DEVELOPMENT APPLICATION ASSESSMENT REPORT

Application Number:	DA2025/0272
----------------------------	-------------

Responsible Officer:	Ryan Fehon
Land to be developed (Address):	Lot 21 DP 236849, 6 Lockhart Place BELROSE NSW 2085
Proposed Development:	Alterations and additions to a dwelling house
Zoning:	Warringah LEP2011 - Land zoned R2 Low Density Residential
Development Permissible:	Yes
Existing Use Rights:	No
Consent Authority:	Northern Beaches Council
Delegation Level:	DDP
Land and Environment Court Action:	No
Applicant:	Angela Howes

Figure 1 - Extent of Building Envelope Non-Compliance on North-Eastern Elevation

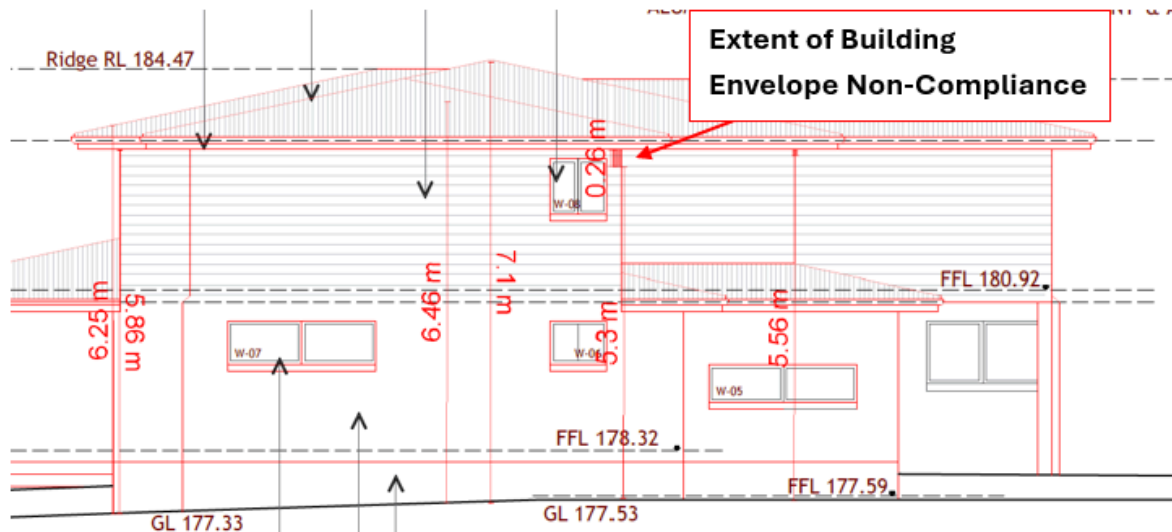
There is a proposed 260mm exceedance of the WDCP B3 Side Boundary Envelope control. This is a 6.5% variation of the numerical requirement, with a corner of the proposed first floor ensuite on the north-eastern elevation of the first floor being the point of encroachment. This encroachment has been displayed in **Figure 1**.

The non-compliance is minimal in length, with the side setback changing on the north-east boundary consistently. The 260mm maximum non-compliance occurs to the corner of the proposed first floor ensuite, not travelling throughout the entirety of the room. It is considered that the non-compliant area, which only occurs at the corner of the ensuite structure, is minimal and does not warrant and further changes to the design.

Due to the non-compliance not relating to the entirety of a room, wall or facade, it is considered that the proposal is acceptable in its revised state. This extent of non-compliance does not have the potential to significantly affect the light and solar access of the neighbouring lot to the northwest boundary (5 Lockhart Place). The separation of buildings will be a slight reduction on the existing separation, with the secondary dwelling on 5 Lockhart Place (north-

Figure 2 - Rear Setback Encroachment (note: blue area represents the rear setback area)

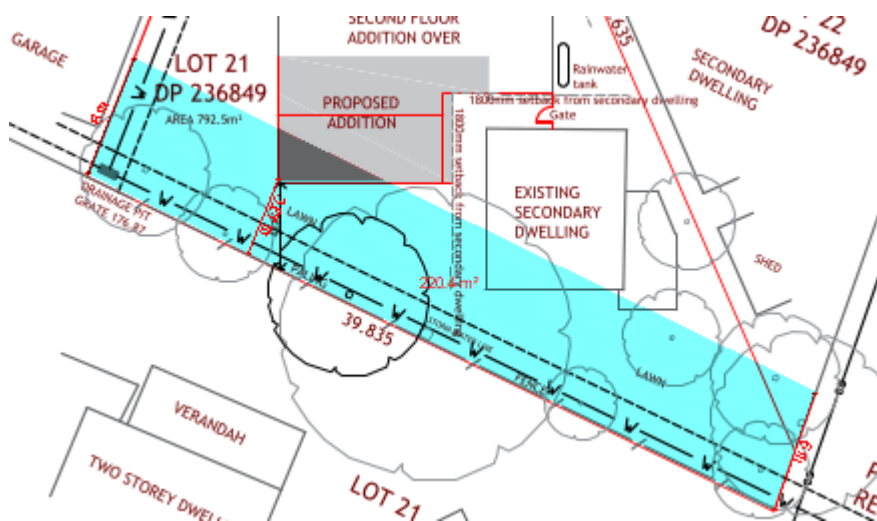
The development does not comply with the 6m rear setback requirement, which is outlined by part B9 Rear Boundary Setbacks of the WDCP. The rear decking structure on the ground floor encroaches into the 6m rear setback area by 2.13m for a rear setback measurement of 3.87m. This is a 35.5% non-compliance of the 6m requirement.

The first floor addition was originally proposed to be non-compliant and follow the structure of the ground floor structure, however Council stated that this position would not be supported. Amendments were requested by Council and changes were made in accordance with these, with the applicant ensuring the rear setback is fully compliant at the first floor level.
